Attachments to item number 5.1 -

RESPONSE TO ITEM 5 ON RFI 16/02/2022 E15 INUNDATION PRONE AREAS CODE

TO	John Lewis	DATE	12/10/2022
FROM	Dale Hayers	TIME	
PROJECT	5 Station Lane Offices	PROJECT N ^o	21.0212
SUBJECT	Response to Council RFI	REF N ^o	EA-C01

Development Application: Response
to Not Satisfied Information Request -
5 Station Lane, Sorell
Plans Reference: P3
Date Received: 9/01/2023

Figure 1. Sorell Council Flood Hazard Mapping

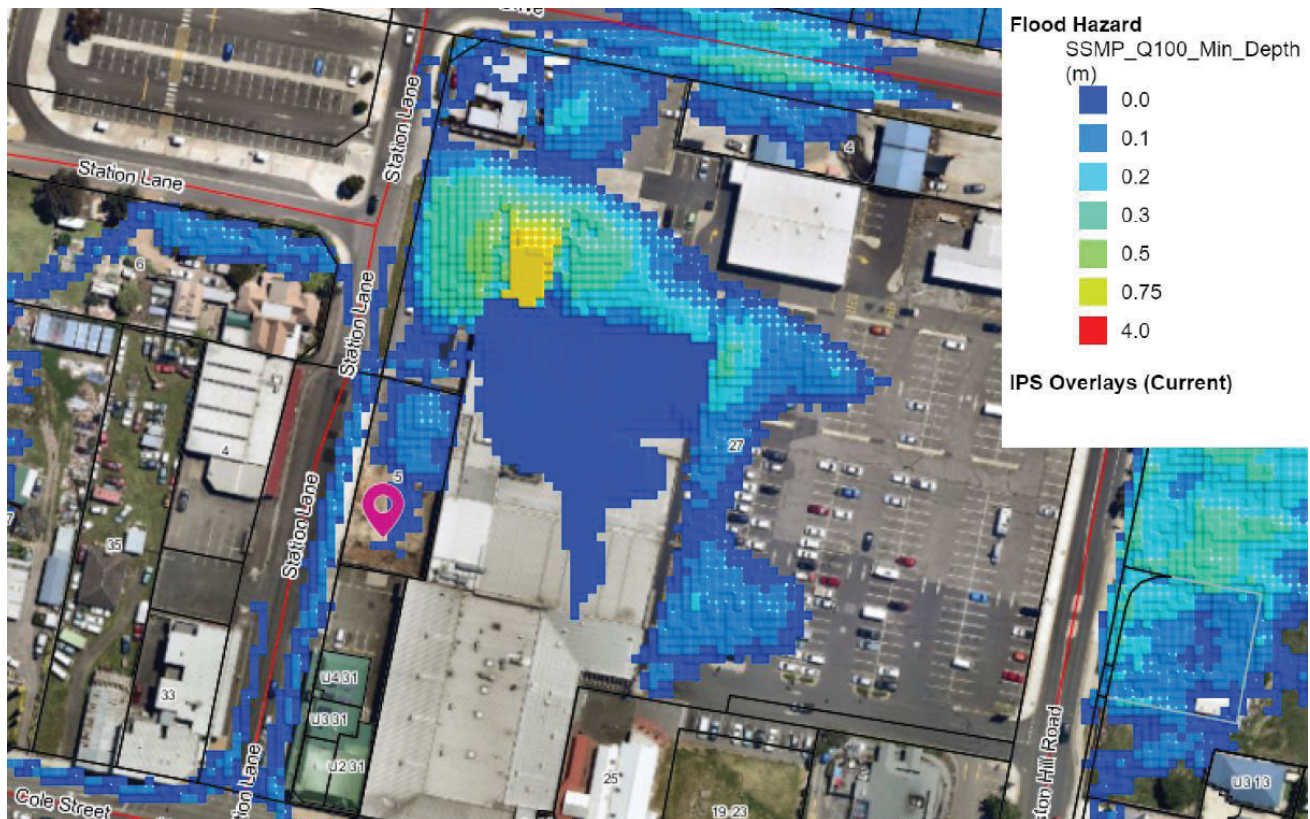
5. Council has draft inundation / flood mapping which is shown to potentially impacting your site (see attachment). Consequently as the property is deemed to be within Code E15.0 Inundation Prone Area, under the Sorell Interim Planning Scheme 2015, please provide evidence of compliance with this Code which may include an inundation vulnerability report that includes an inundation risk management plan, prepared by a suitably qualified person, in accordance with best practice guidelines which details;

The flood footprint in Figure 1 shows minor flooding in the 1% AEP, ranging from 0 to approximately 100mm on the site. This would provide minimal risk the proposed development assuming nominal finished floor levels are provided.

Although the public pipe and pit stormwater infrastructure seems to have been used in the Entura modelling, it is unlikely that private stormwater infrastructure, such as the pits and pipes servicing Woolworths and the large carpark, were surveyed or modelled for the production of the flood map. Therefore, it is likely that the modelled flood footprint in Figure 1 is greater than what would be anticipated in the 1% AEP, if private drainage of Woolworths carpark and surrounding businesses was included in the model.

Figure 1 MUSIC model treatment train results using a EnviroAustralis G30 Treatment Device

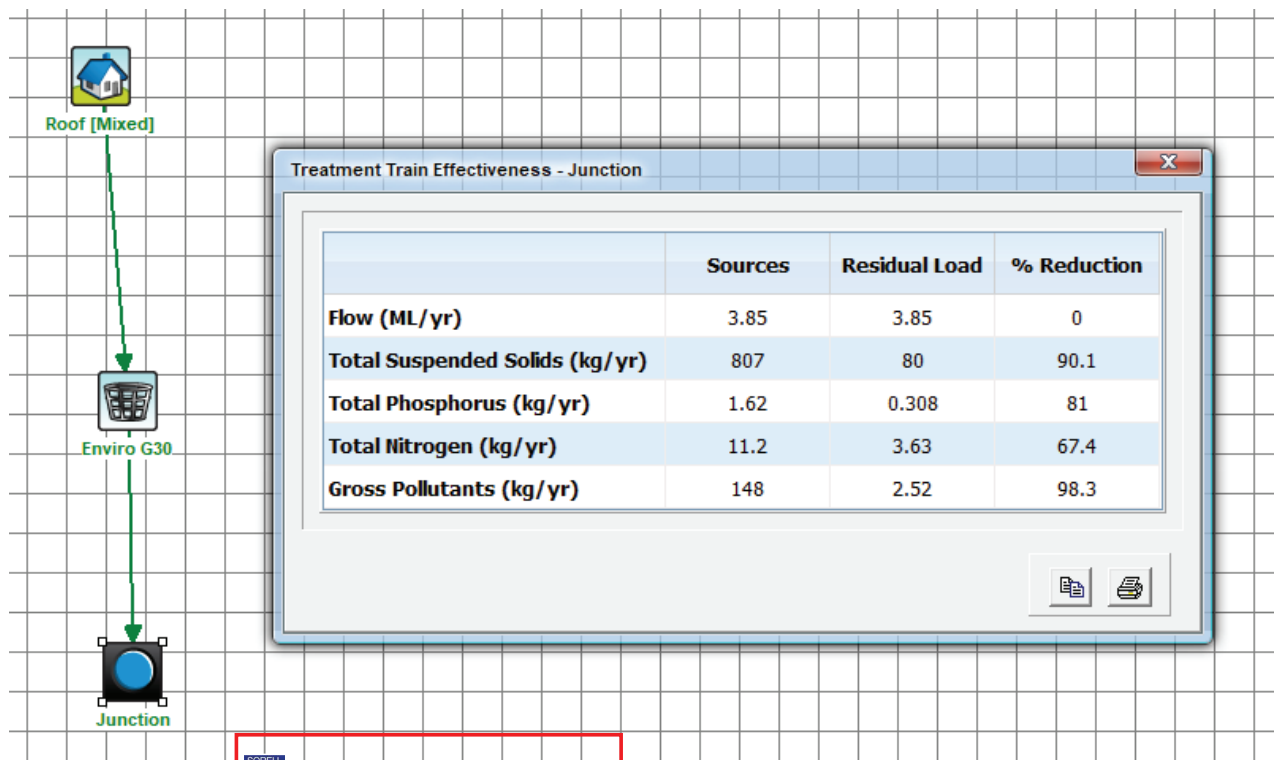
The purpose of this Engineers Advice is to address Item 13 in the Request for Additional Information from Sorell Council dated 16.02.2022. This Advice shall be read in conjunction with the Gandy and Roberts Concept Servicing Plan C020 Revision A.

It is proposed that the roof runoff will be treated upstream of the detention tank via an above ground solution located under the fire stair. Many mechanical treatment devices are available to cater for roof treatment and the final design solution is to be confirmed during detailed design. One such system capable of achieving treatment targets as defined in the Sorell Interim Planning Scheme Table E7.1 is the EnviroAustralis G30. Treatment train results as provided by MUSIC Version 6.3.0 are shown in Figure 1.
